Sheet: /
File: Main Board.sch
Title: Synth V1
Size: A4
Date:
Rev: 1
KiCad E.D.A. kicad 4.0.7-e2-637658ubuntu17.04.1
Id: 1/2

Title: Main Board Connections

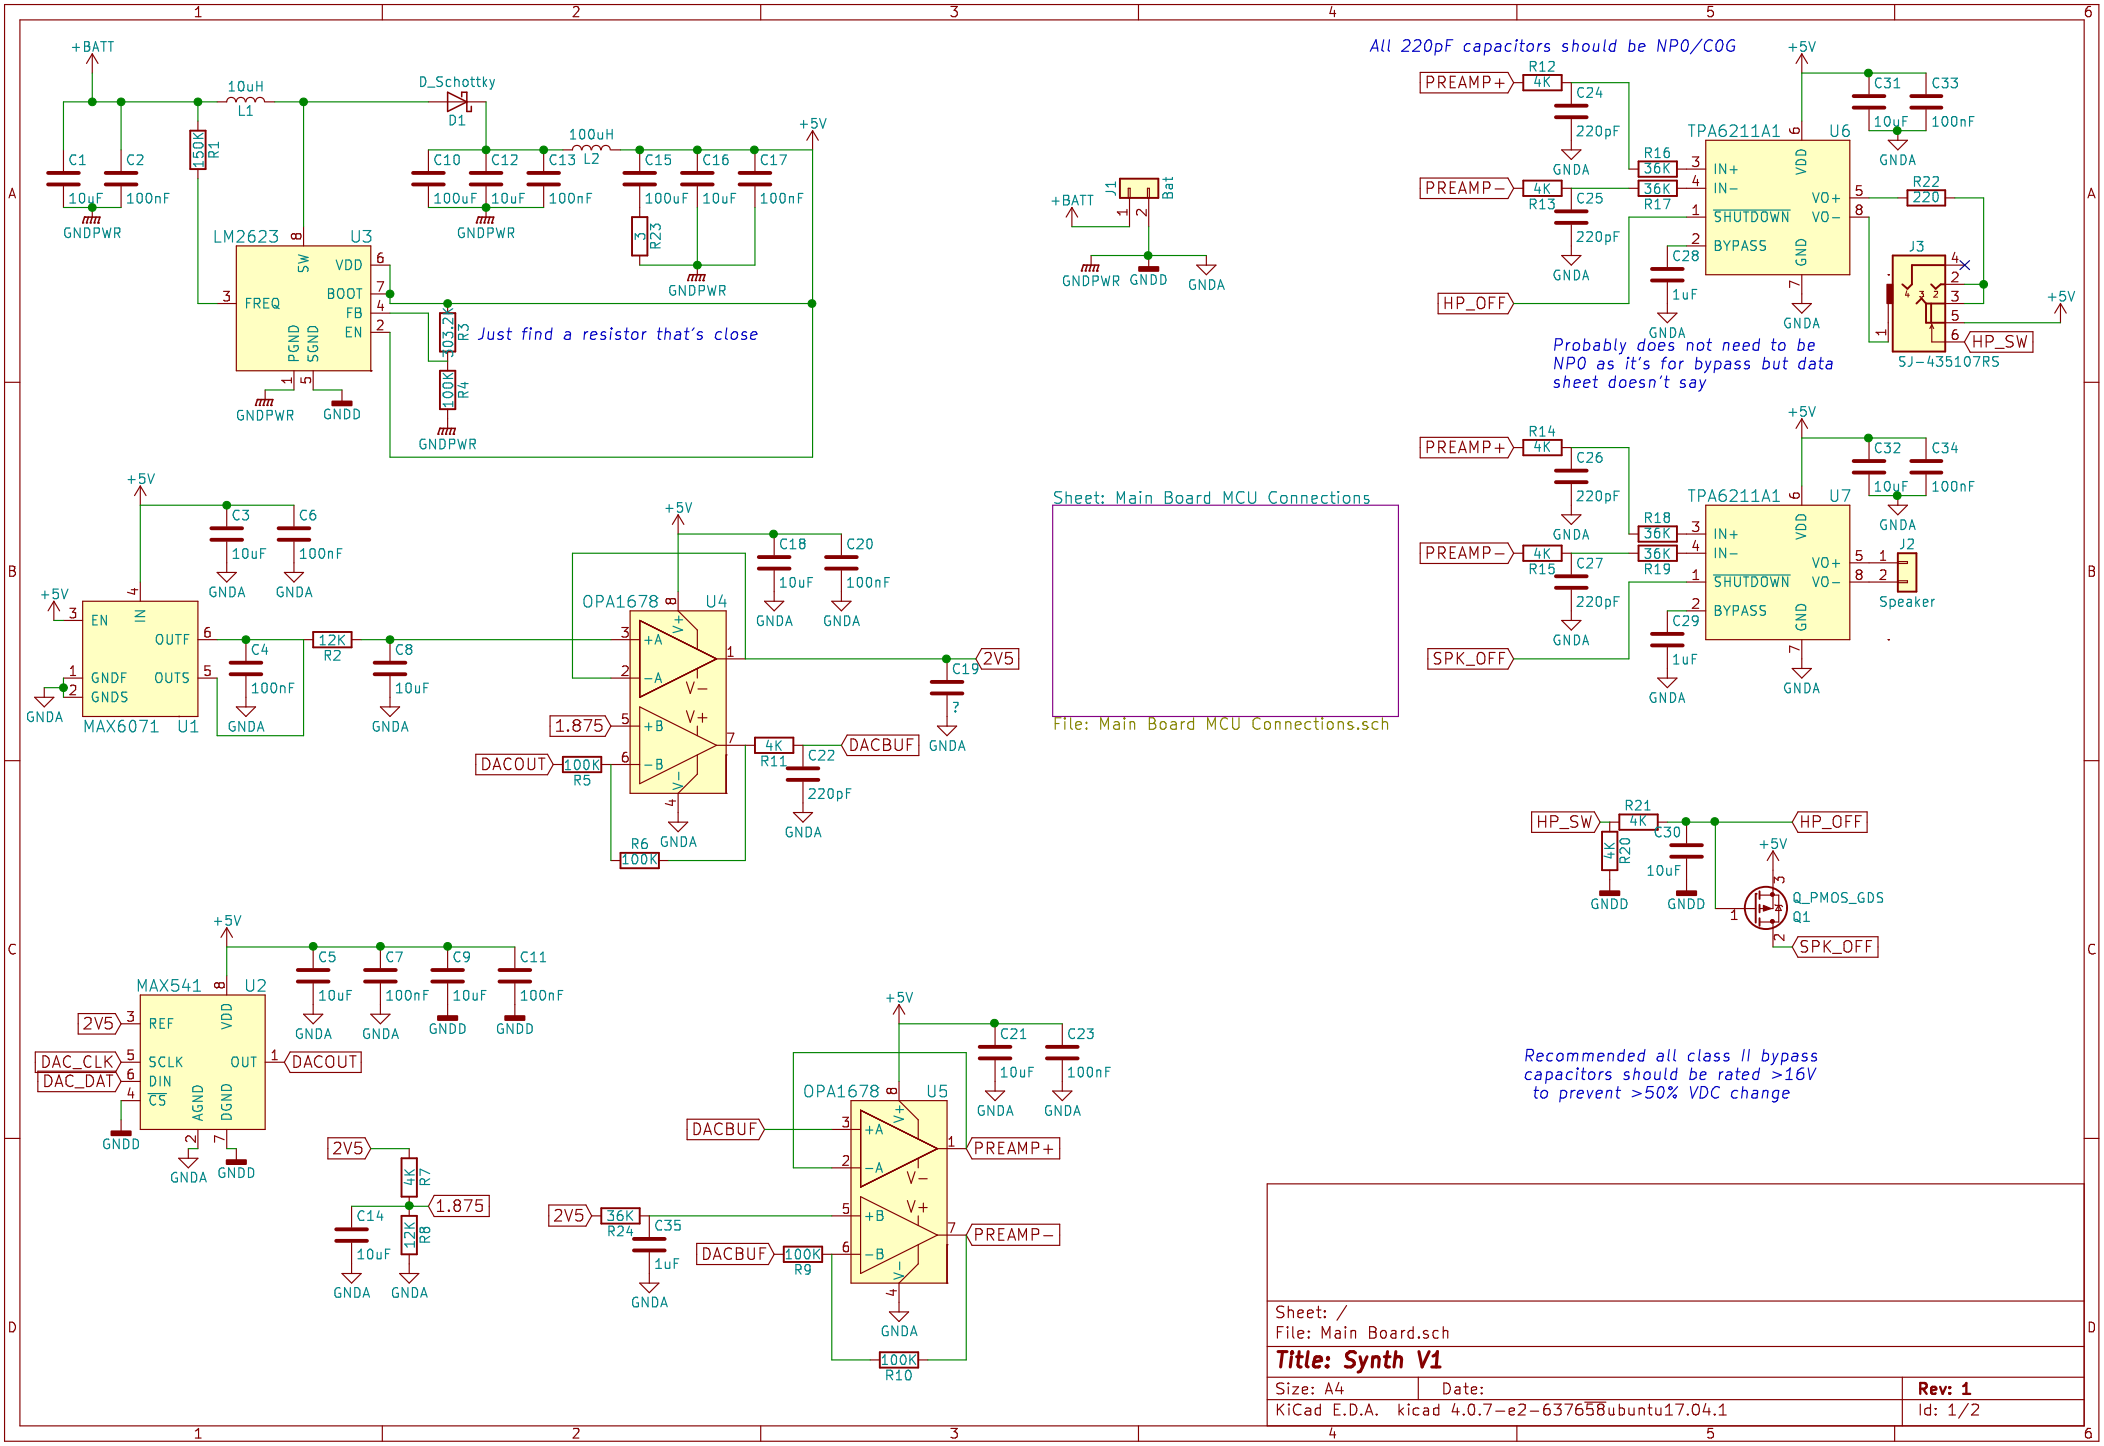
+BATT
10uH
L1
D_Schottky
D1
C1
C2
10uF
100nF
150K
R1
GNDPWR
LM2623
U3
SW
VDD
BOOT
FB
EN
FREQ
PGND
SGND
GNDD
C10
C12
C13
L2
100uH
C15
C16
C17
+5V
R23
3
103.2
R3
100K
R4
Just find a resistor that's close
J1
Bat
GNDA
All 220pF capacitors should be NPO/COG
PREAMP+
PREAMP−
HP_OFF
R12
R13
4K
C24
C25
220pF
R16
R17
36K
TPA6211A1
U6
IN+
IN−
SHUTDOWN
BYPASS
VDD
VO+
VO−
GND
C28
1uF
C31
C33
R22
220
J3
SJ-435107RS
HP_SW
Probably does not need to be NPO as it's for bypass but data sheet doesn't say
R14
R15
C26
C27
R18
R19
U7
C32
C34
J2
Speaker
SPK_OFF
C29
C3
C6
C4
C8
EN
IN
OUTF
OUTS
GNDF
GNDS
MAX6071
U1
12K
R2
OPA1678
U4
+A
−A
+B
−B
V−
V+
C18
C20
C19
2V5

1.875
DACOUT
100K
R5
R6
4K
R11
C22
DACBUF
Sheet: Main Board MCU Connections
File: Main Board MCU Connections.sch
HP_SW
R21
R20
C30
10uF
Q_PMOS_GDS
Q1
MAX541
U2
REF
SCLK
DIN
CS
AGND
DGND
OUT
DAC_CLK
DAC_DAT
C5
C7
C9
C11
R7
R8
C14
OPA1678
U5
C21
C23
PREAMP+
PREAMP−
R24
36K
C35
1uF
R9
R10
Recommended all class II bypass capacitors should be rated >16V to prevent >50% VDC change
